Central Coast
LOCAL PLANNING PANEL MEETING
Business Paper
10 June 2021

3.1 DA 55715/2018 - 35-45 Clarence Road, Springfield - Four (4) lot
subdivision14

Item No: 3.1
Title: DA 55715/2018 - 35-45 Clarence Road, Springfield
- Four (4) lot subdivision
Department: Environment and Planning

| 1 | DA 55715 - 35 Clarence Rd Springfield - Amended Subdivision Plan | D14374197 |

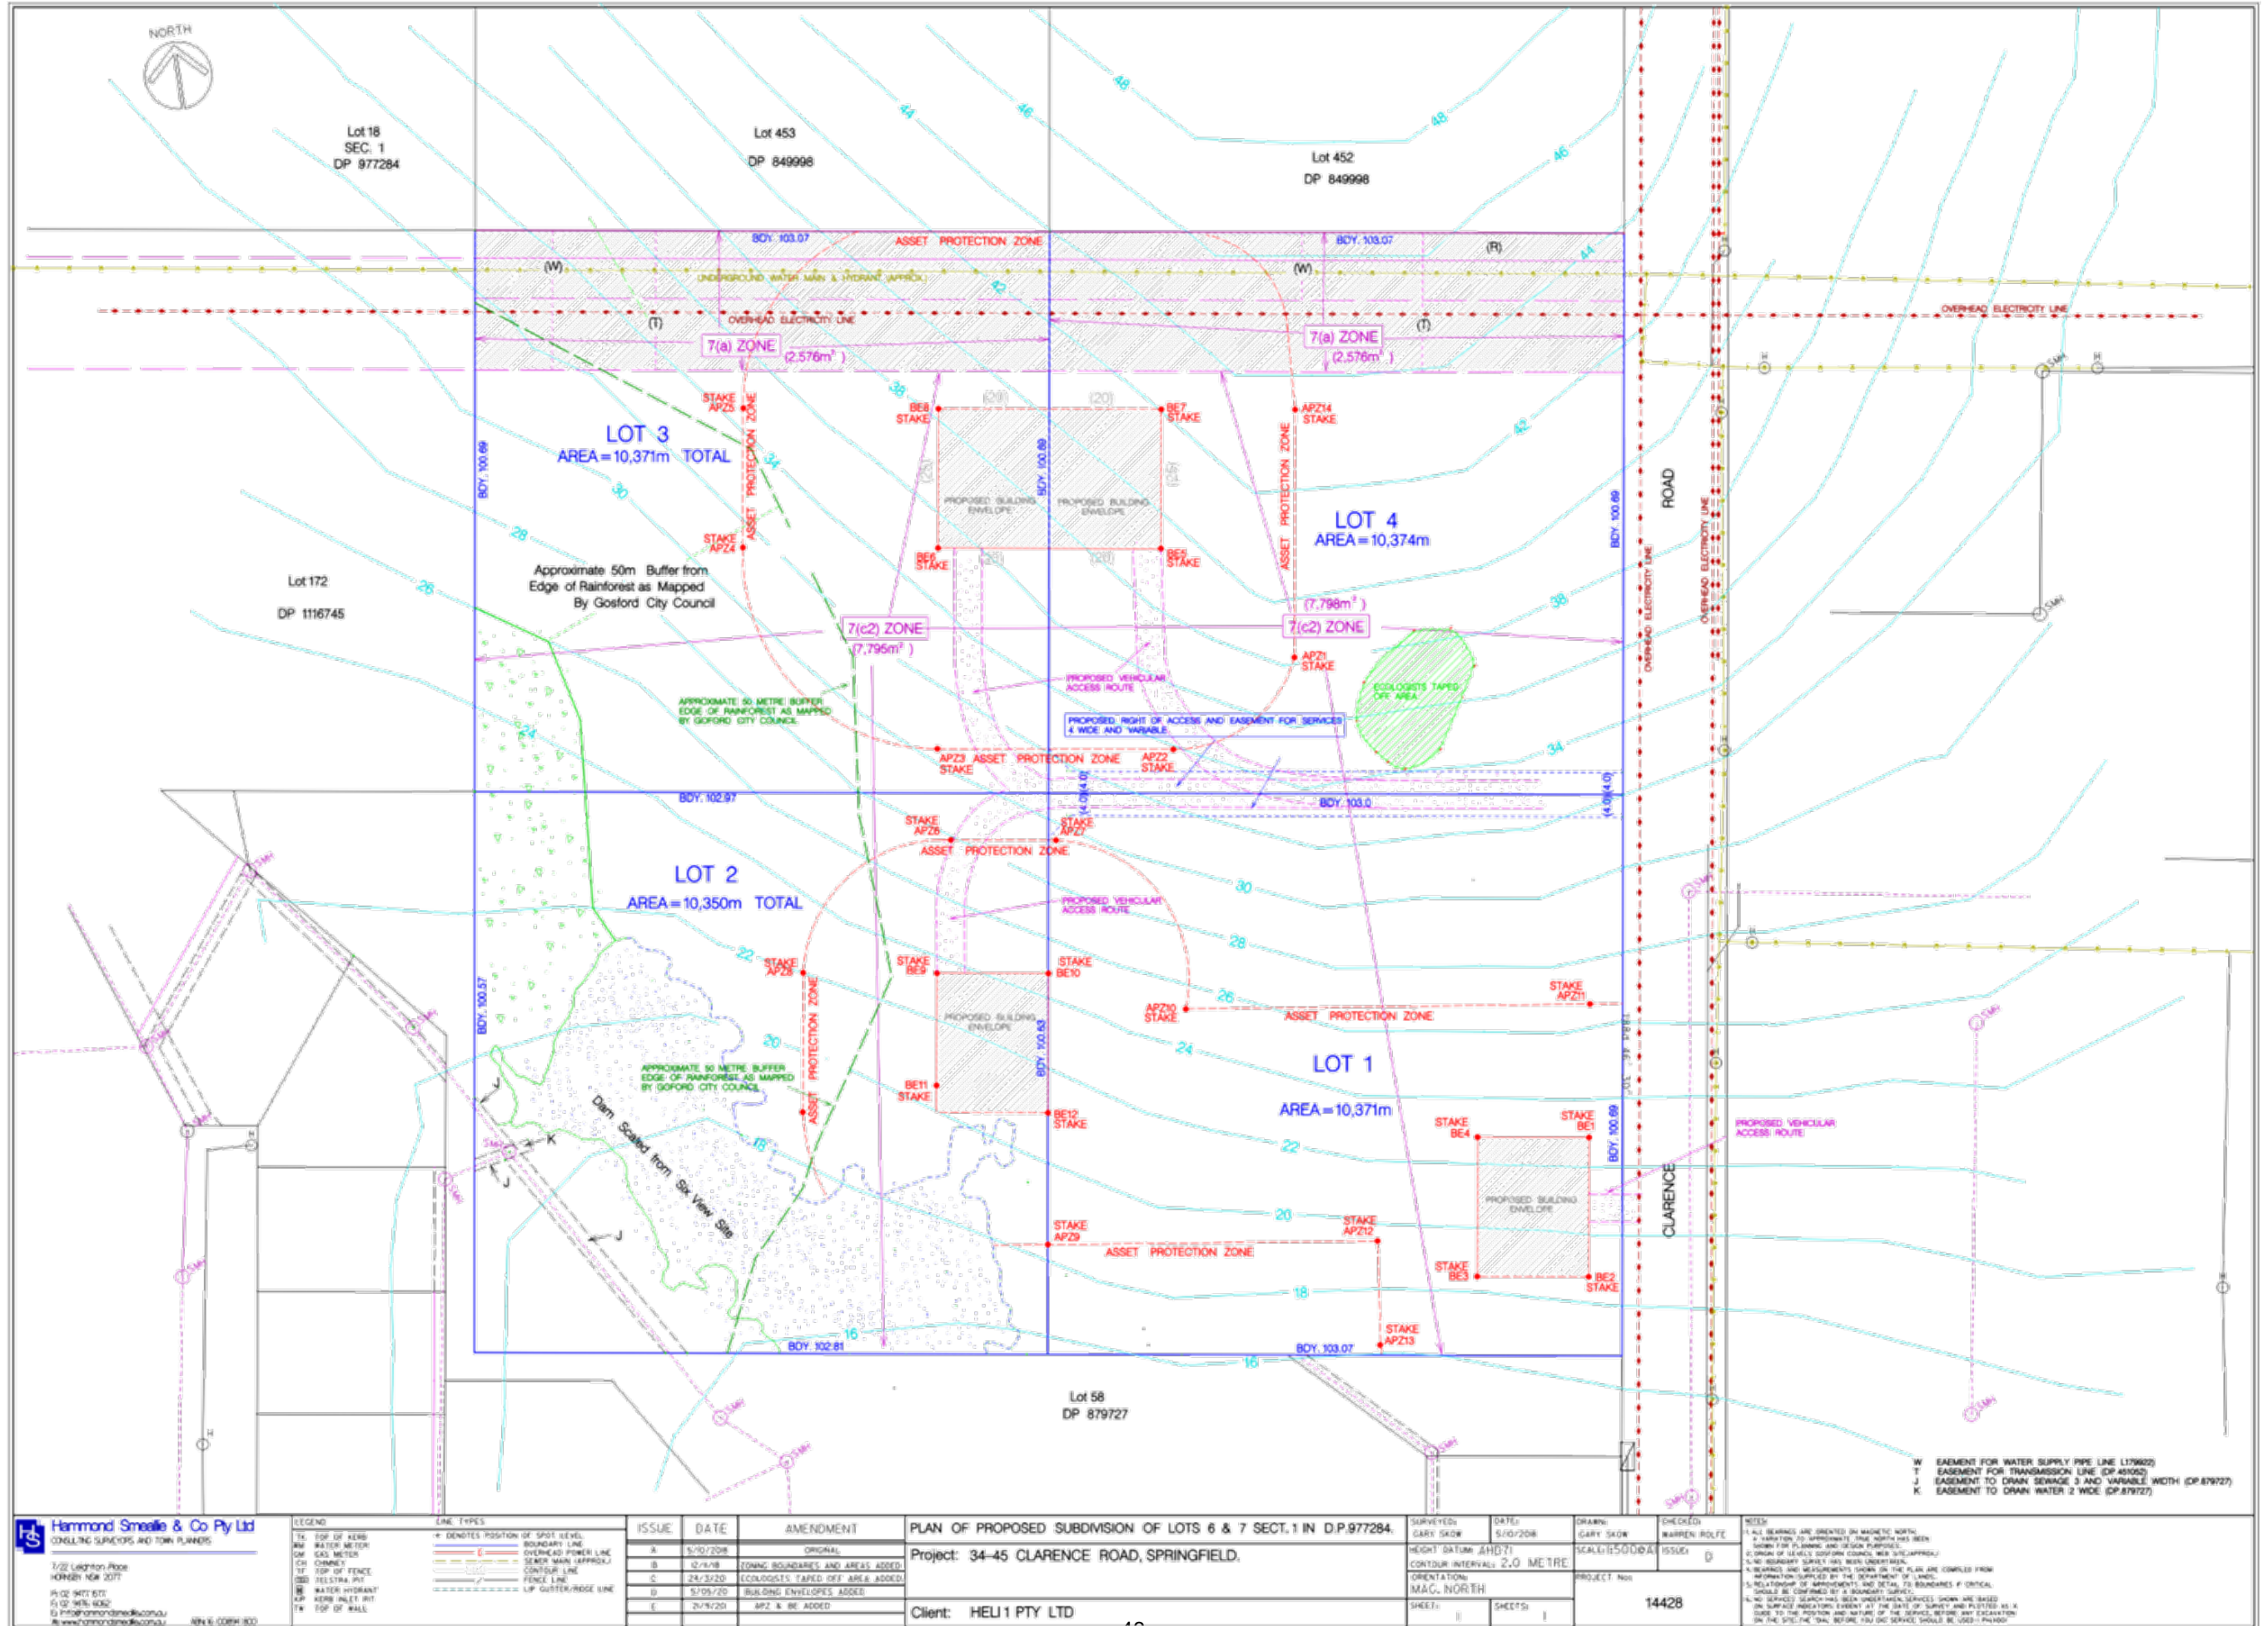
The contours on the amended plan appear to be approx. 15m too high. If so plans need to be amended to reflect actual RLs

- The subdivision plan shows a larger APZ than that shown in the amended bushfire assessment for Lot 1. This would need to be corrected.
- The APZs for two of the lots are still within the Rainforest buffers required by the Gosford Rainforest Policy and clearing of native trees and vegetation is proposed inside that buffer on both lots.

- Reduce the APZ for Lot 3 (and possibly Lot 4) by increasing the BAL level to remove the need for clearing in the rainforest buffer area.
- All plans need to be consistent. The current subdivision plan shows a larger APZ for Lots 1 and 2 than that shown in all the reports.

- Move access south at least 10 metres to provide a vegetated buffer to the Rhodamnia population.
- Show the turning heads required by RFS (and the Bushfire Assessment) on the subdivision plans and assess the impact on trees in the amended Arboricultural Impact Assessment report.

- Move the building envelope and corresponding APZ on Lot 2 further east to remove the need for clearing in the rainforest buffer area. The lot boundary would also need to be adjusted accordingly.
